La Vista City Centre

CITY OF LA VISTA
PLANNING DIVISION

RECOMMENDATION REPORT

CASE NUMBER: 2016-SUB-04

SHEET
C2.1

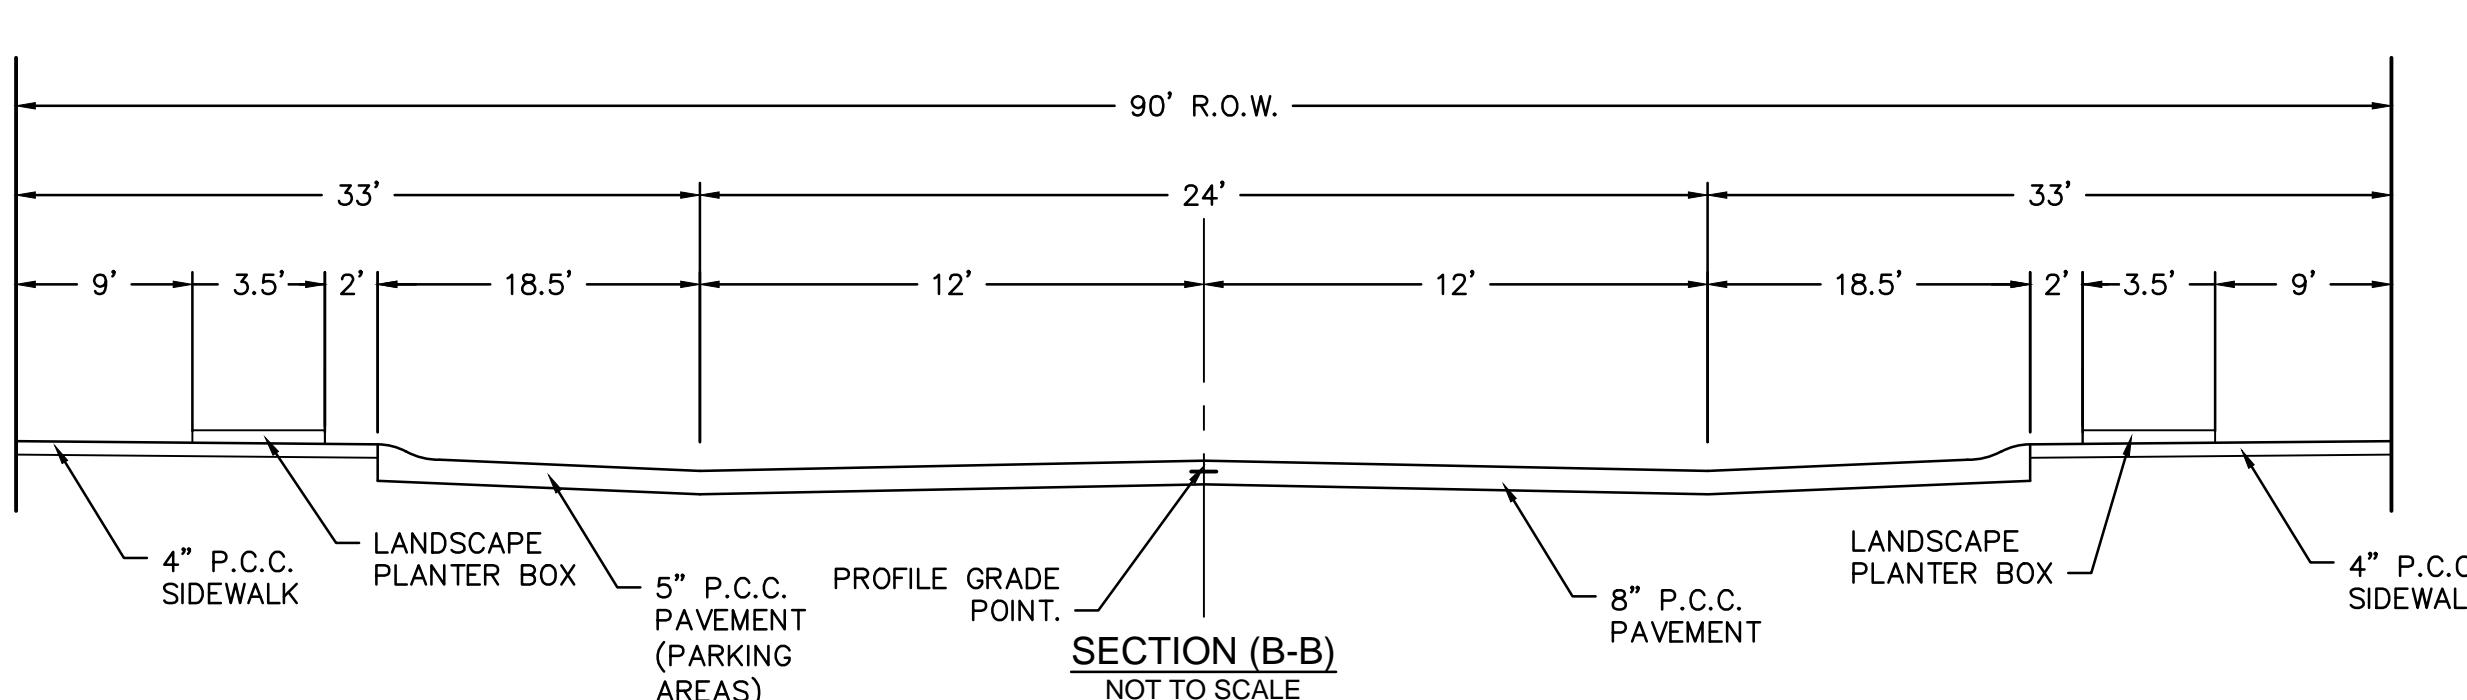
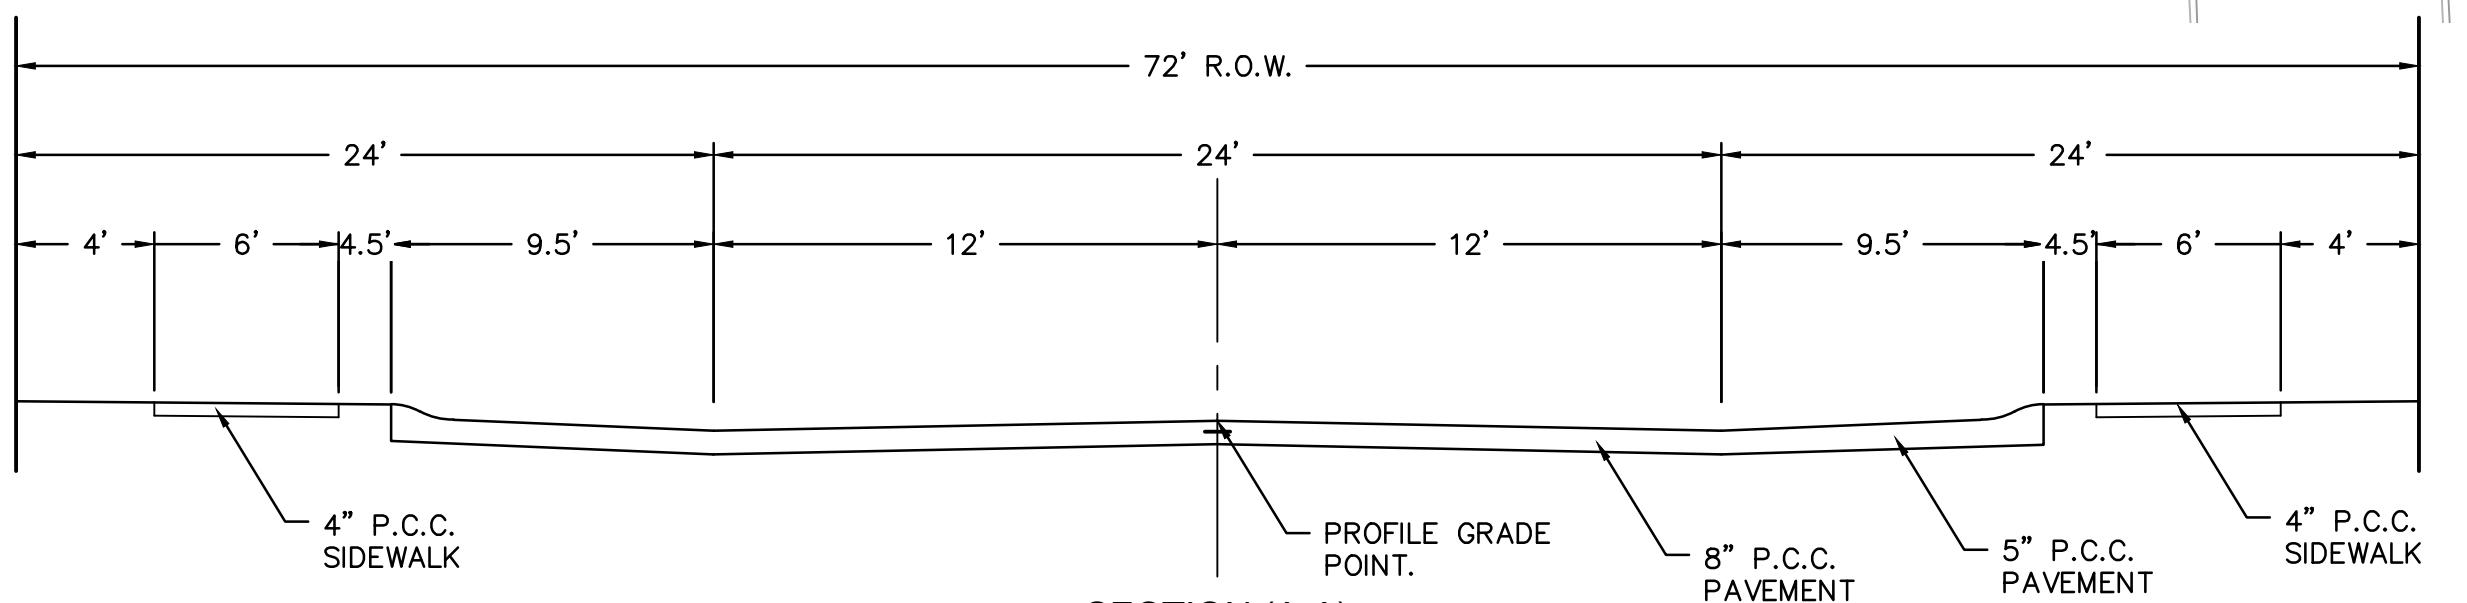
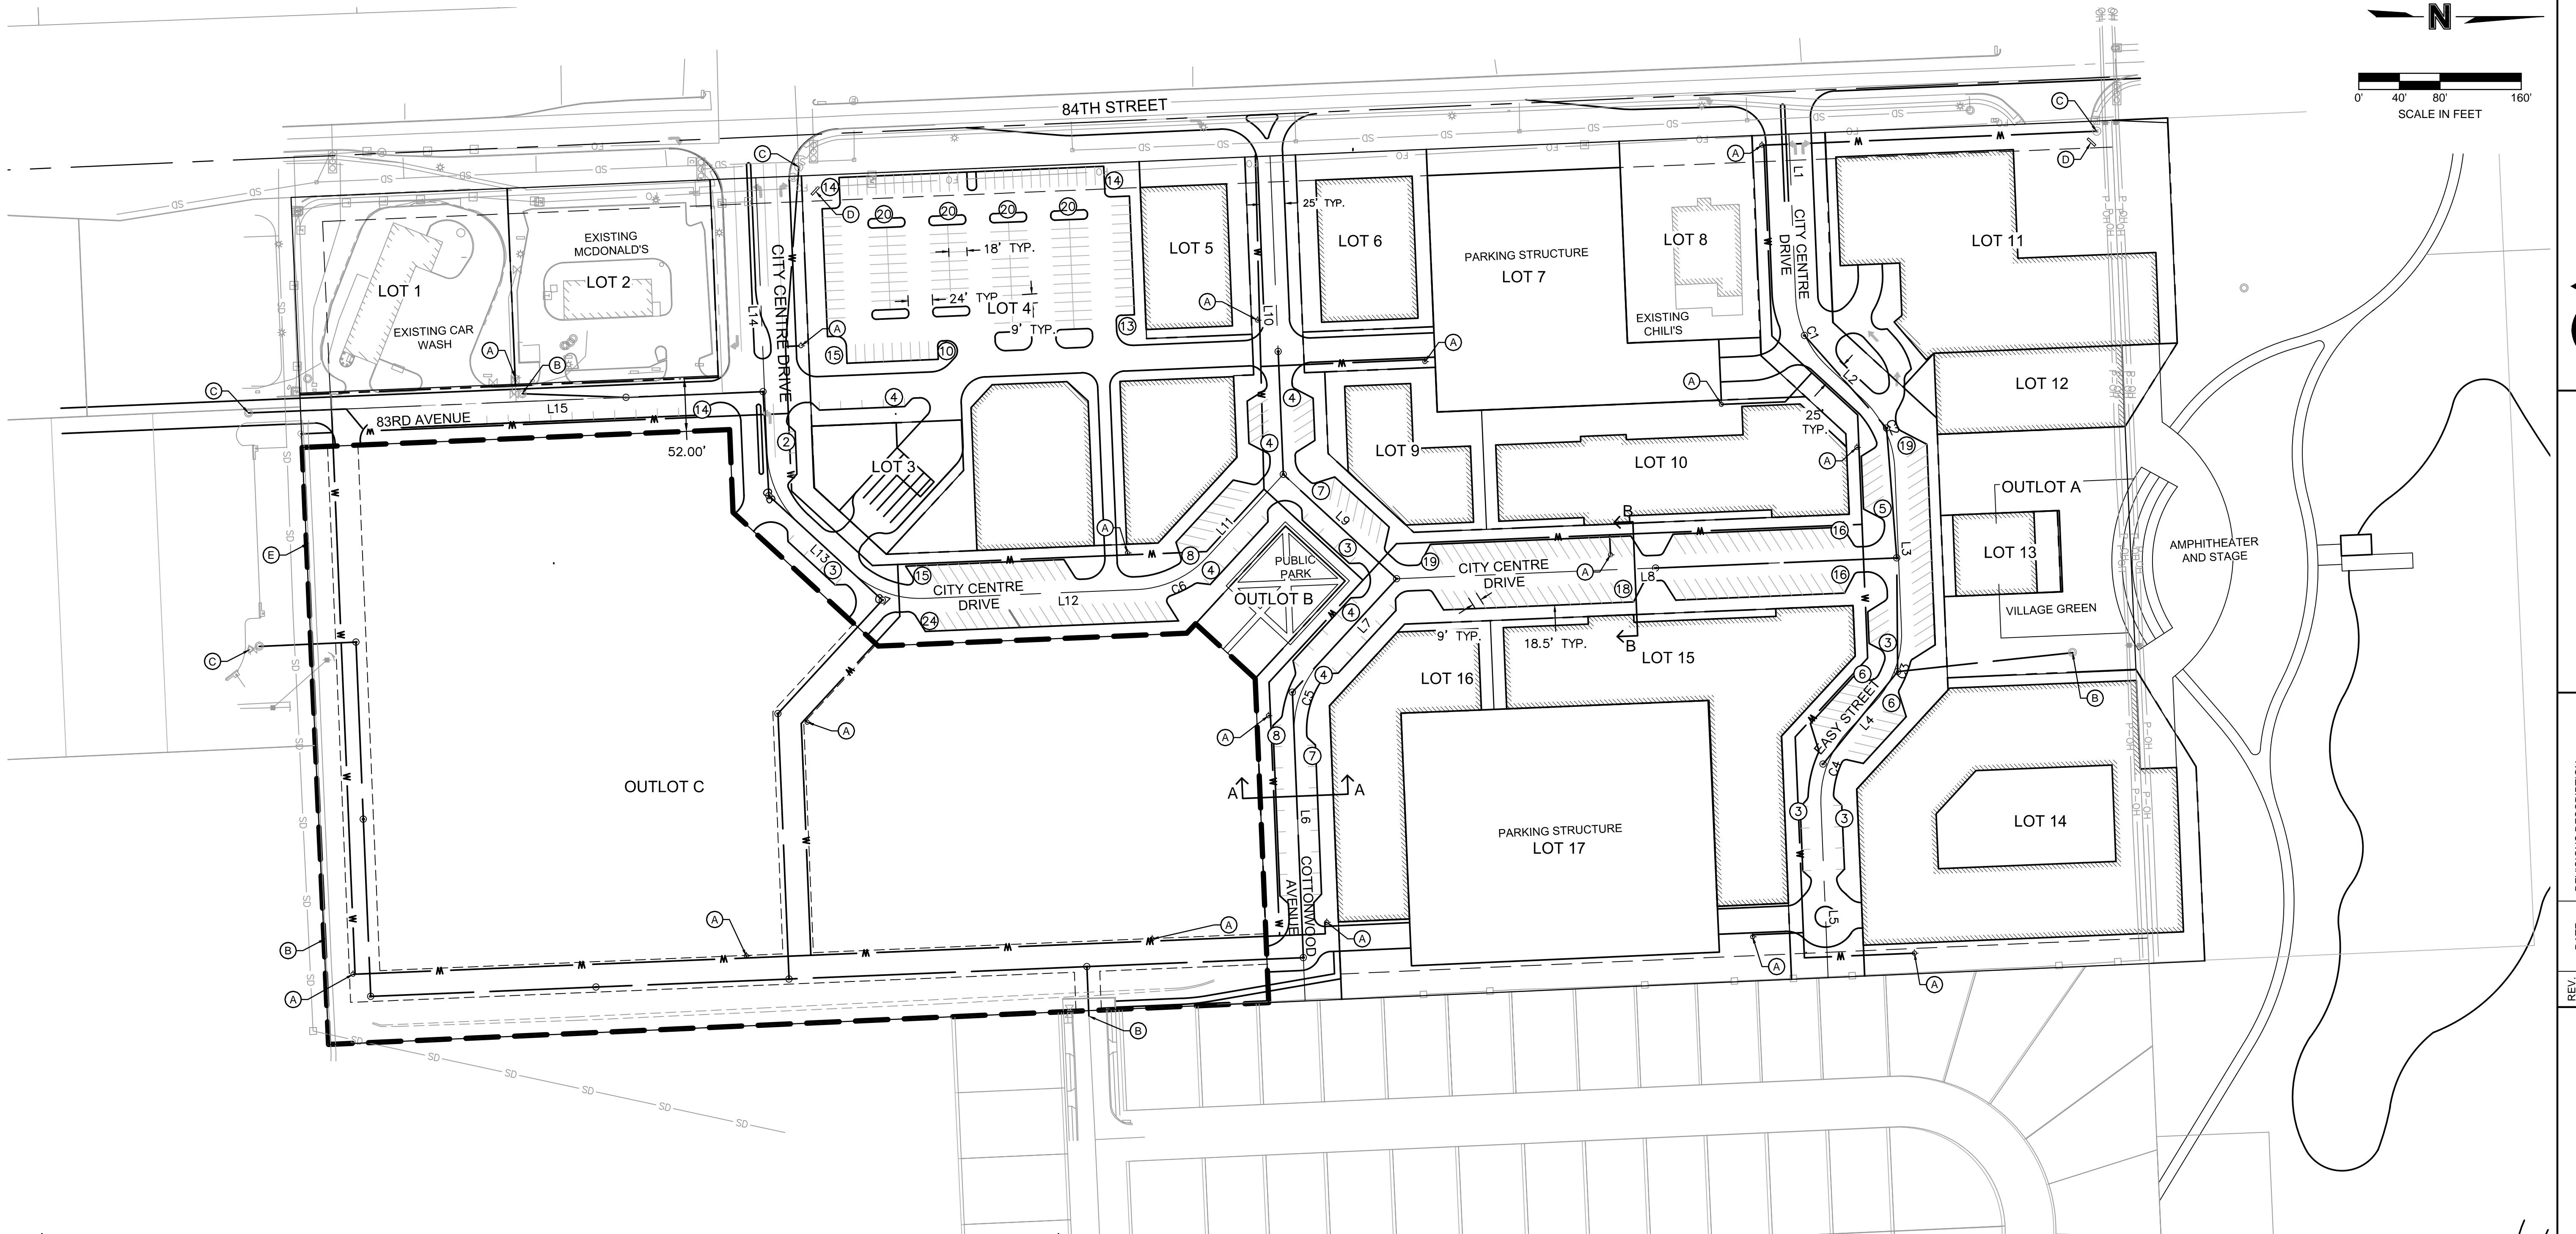
8. There is an existing sanitary sewer that connects to Wiltham Place in the existing sewer easement shown on C2.1. The proposed utility plan on Sheet C3.1 will need to provide for reconnecting that sewer and relocating as appropriate.

Response: Sewer service will be provided to Wiltham Place

drawn by: CAS
checked by: ERS
approved by: ERS
QA/CC by: ERS
project no.: 016-0546
drawing no.: 016-0546
date: 04.04.2016
SHEET C3.1

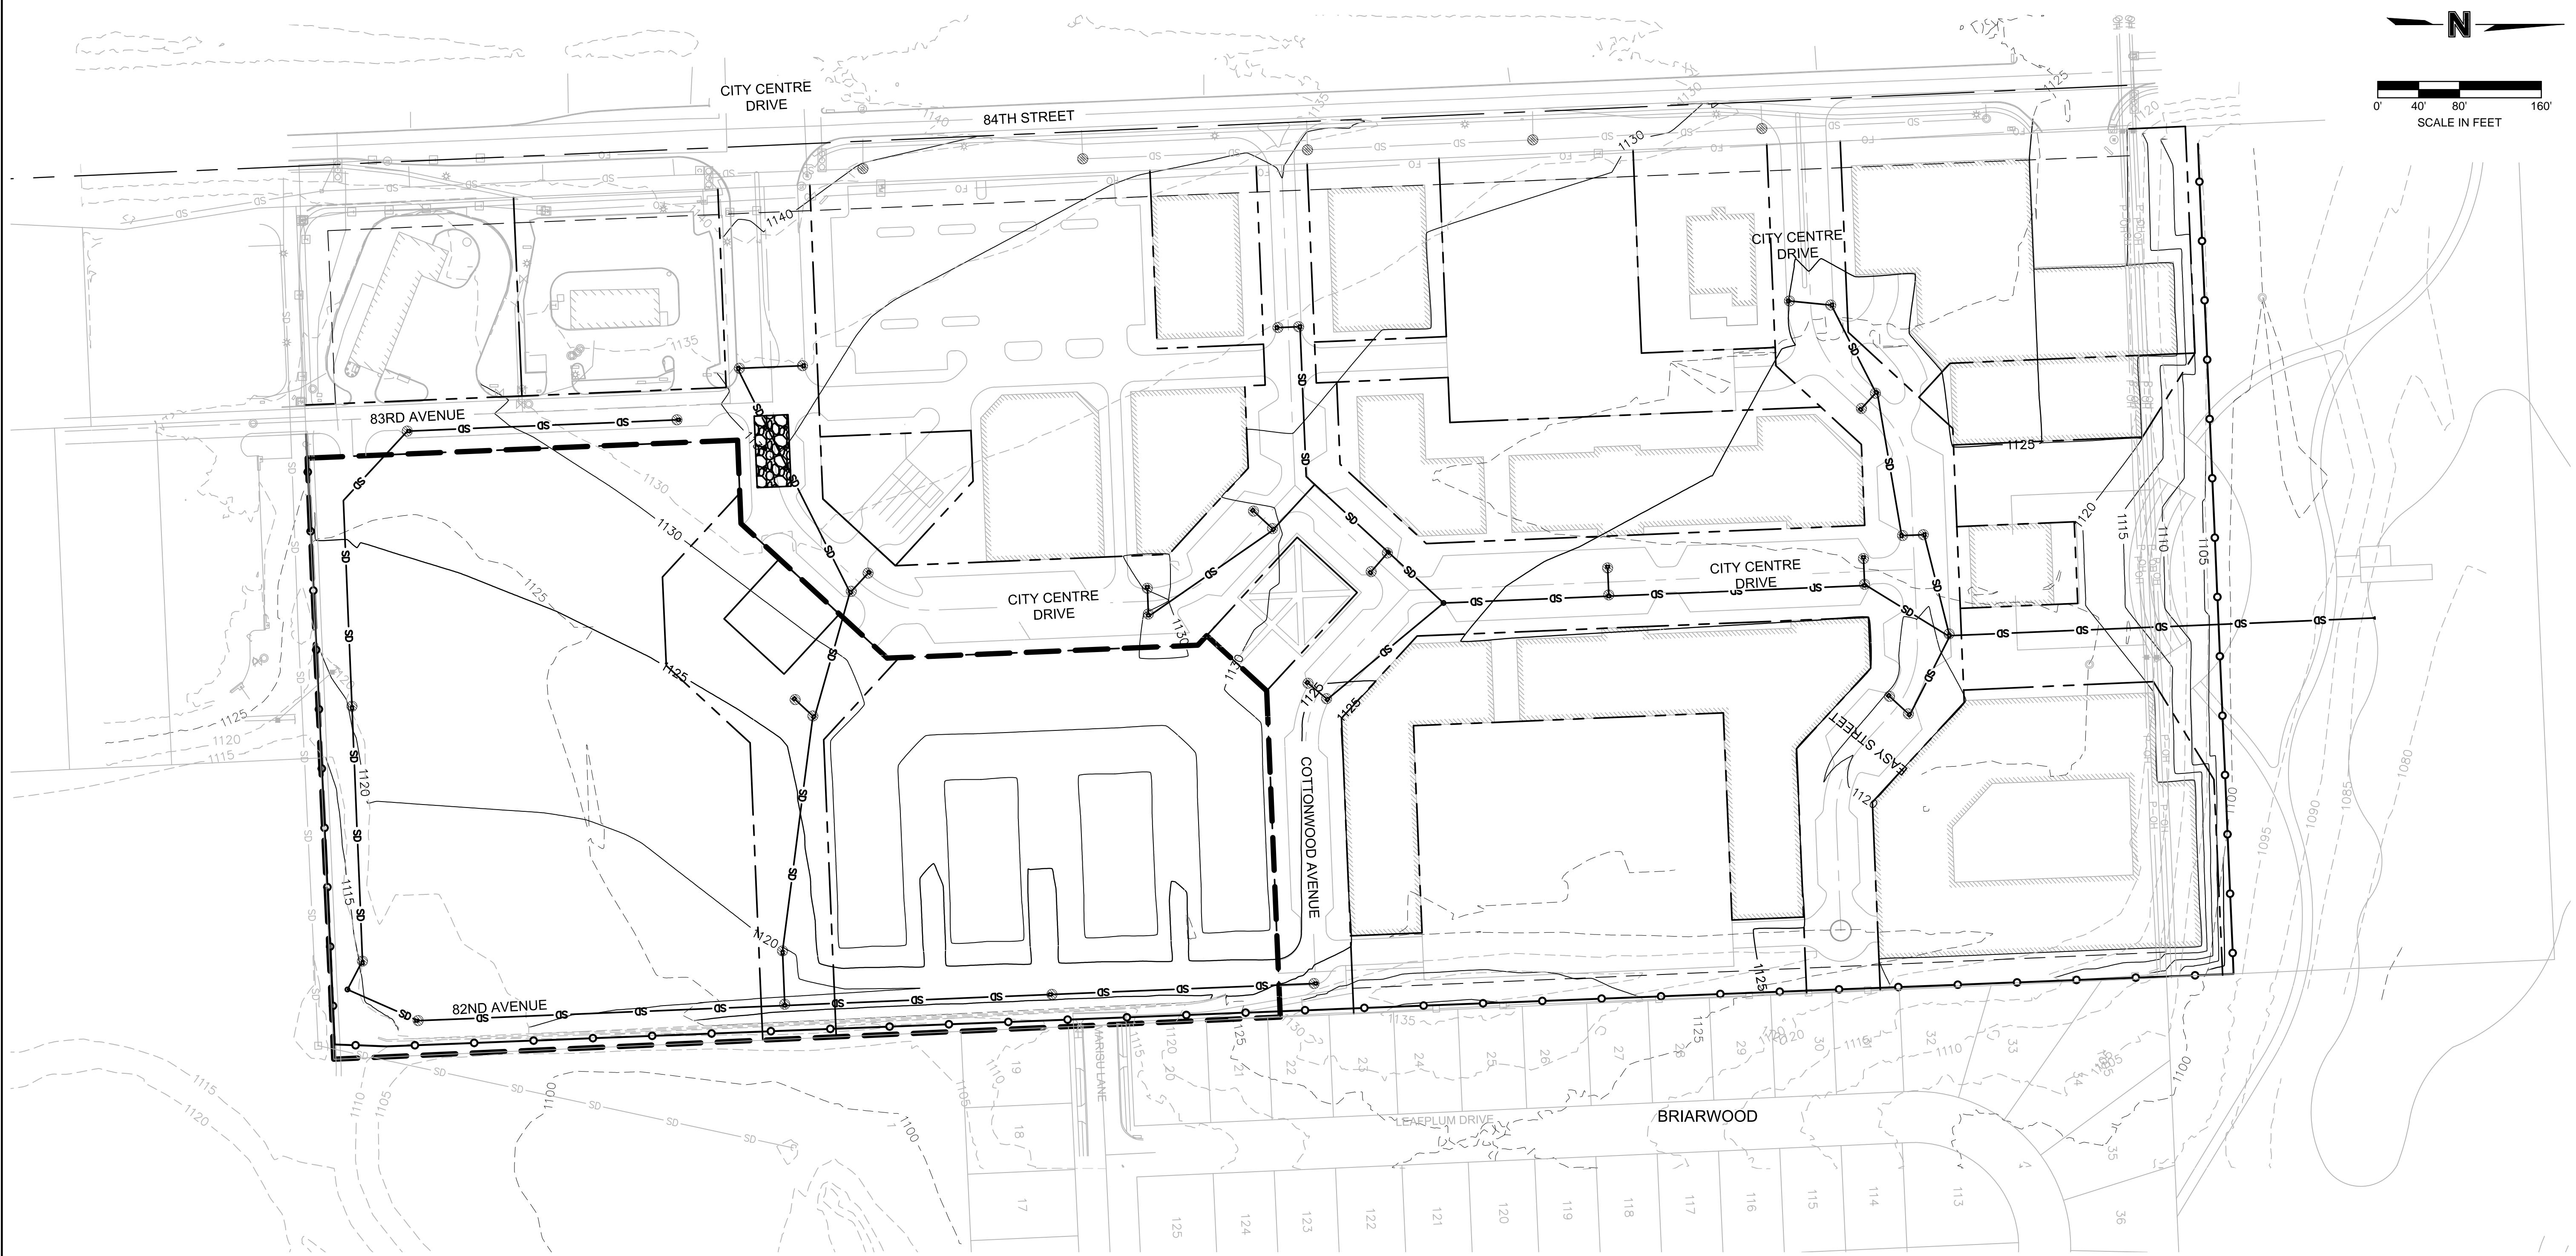
15. The proposed pavement type and thickness needs to be noted on Sheet C3.1 in the typical sections. This is needed per Article 3.03.20(3) of the Subdivision Regulations.

18. Note 1 on Sheet C3.1 indicates gas to be provided by MUD. Gas will be provided by Black Hills Energy.
19. The existing Chili's configuration on proposed Lot 7 should be shown as we understand that facility is to remain in its current configuration. The manner in which that will be incorporated into the project should be shown.

4. The typical sections on Sheet C3.1 indicate pavement thickness of 7 inches. Section 4.24 of the Subdivision Regulations indicates minimum pavement thicknesses. The footnotes to the table in that section indicate a minimum of 8 inches for streets in commercially zoned areas. There should be a discussion with the applicant as to whether the drive aisles in the typical sections could be 8 inches thick and the parking stalls could be 6 inches thick. If the streets remain at 7-inches thick, then a waiver request should be processed.

Response: Proposed pavement thicknesses have been noted per the City's subdivision regulations.

Response: The note has been updated

Response: The typical section pavement thickness has been increased to 8 inches per the Subdivision Regulations and preliminary geotechnical report. Parking stall pavement thickness has been set at 5 inches per the preliminary geotechnical report.
